DEVELOPMENT APPLICATION ASSESSMENT REPORT

Application Number:	DA2021/1183
----------------------------	-------------

Responsible Officer:	Catriona Shirley
Land to be developed (Address):	Lot E DP 399909, 8 Bate Avenue ALLAMBIE HEIGHTS NSW 2100
Proposed Development:	Construction of a secondary dwelling
Zoning:	Warringah LEP2011 - Land zoned R2 Low Density Residential
Development Permissible:	Yes
Existing Use Rights:	No
Consent Authority:	Northern Beaches Council
Land and Environment Court Action:	No
Owner:	James Iain Elliott Mari-Jane Elliott
Applicant:	Mari-Jane Elliott

PROPOSED DEVELOPMENT IN DETAIL

Figure 1a: Councils Flood Mapping in relation to the proposed subject site. (Source: SEA Northern Beaches Council)

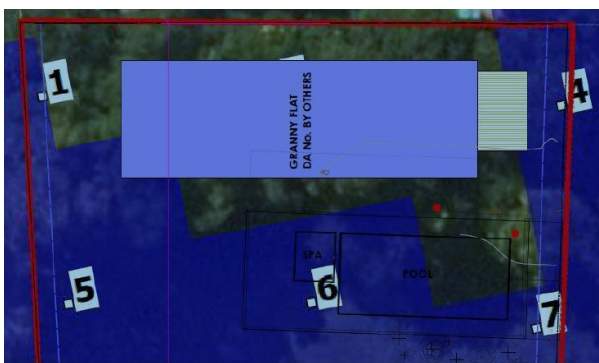
Clause B9 Rear Boundary Setbacks of the WDCP requires that structures be setback 6m from the rear boundary. The proposal fails to achieve compliance with this control, instead proposing a 2.1m setback for the secondary dwelling.

It is important to acknowledge that site constraints influence the location of the proposed works within the rear of the subject site. The subject site is classified as being flood effected, and is located within the Medium Flood Risk Precinct of Northern Beaches Councils Flood Hazard mapping.

As a result, providing built structures above the Probable Maximum Flood (PMF) level (RL 24.48) is recommended and as a result constrains the available area for the secondary dwelling.
